Re: The City of Montpelier

In the following document Veolia Energy has responded to the questions and concerns brought forth by the City of Montpelier and the District Energy Committee regarding the initial Feasibility Study.

Per the City's request we have addressed technical questions surrounding plant capacity, pipe size and capacity, changes in the distribution piping and the layout of the City piping network, hot water distribution temperatures, anti-freeze (glycol), emissions and fuel storage.

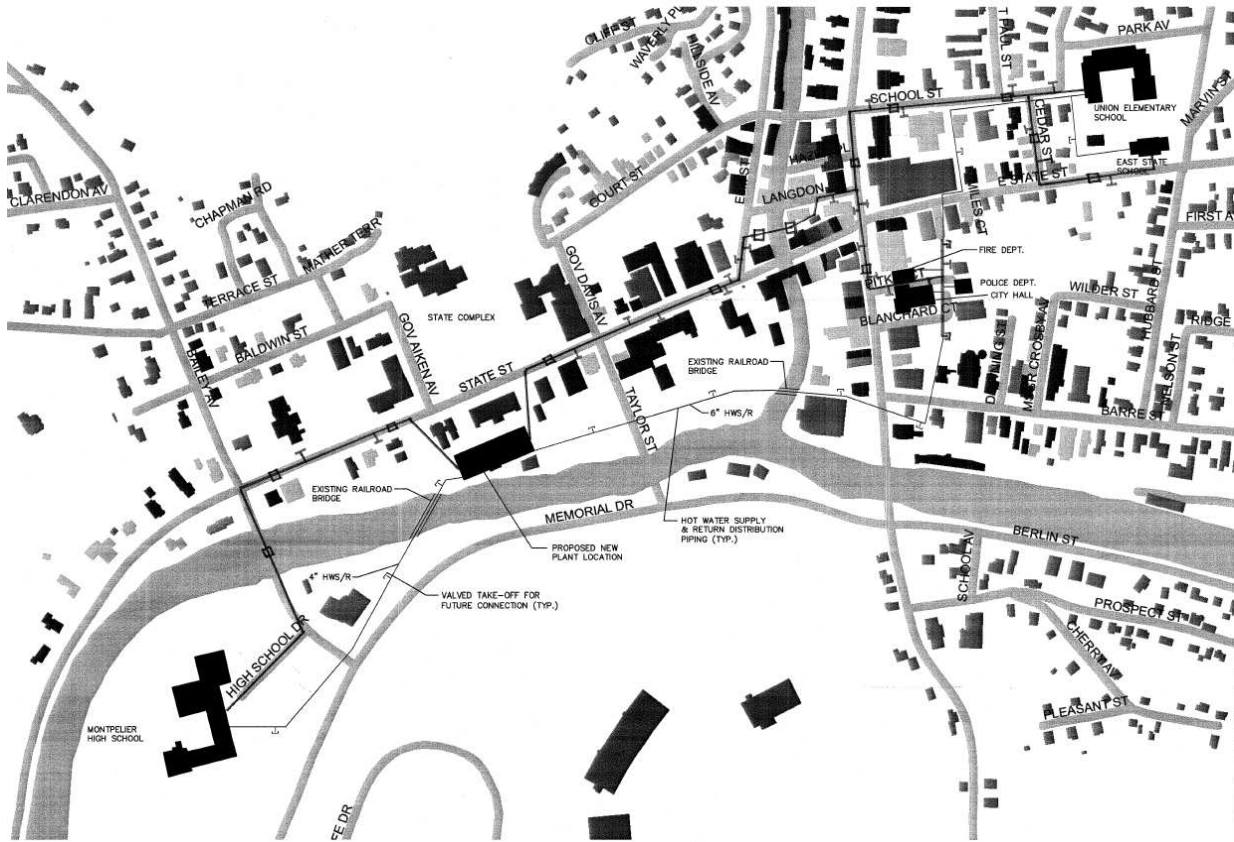
The distribution system routing has been reviewed and altered as requested by the City of Montpelier. The attached drawing depicts the new proposed routing of the system through the city. The new routing is expected to increase the overall project costs and presents new challenges of crossing the North Branch of the Winooski River. To address this new challenge, several options are being considered.

The river crossing at the Langdon and School Street bridges are similar to that of the State Street Bridge. The bridges appear to be in good condition. However, the difficulty lies in the proximity of the river protection wall and building foundations to the bridge footings. The bridge footings appear to abut the building foundations. In order for this design to work, the lines would need to penetrate the bridge abutments or come off the bridge and penetrate through the building foundations. While this solution is possible, it is not desired structurally, and presents additional complexity related to building re-enforcement.

The option that was chosen for this addendum is the use of combination deep excavations on either side of the river, along with directional boring under the river.
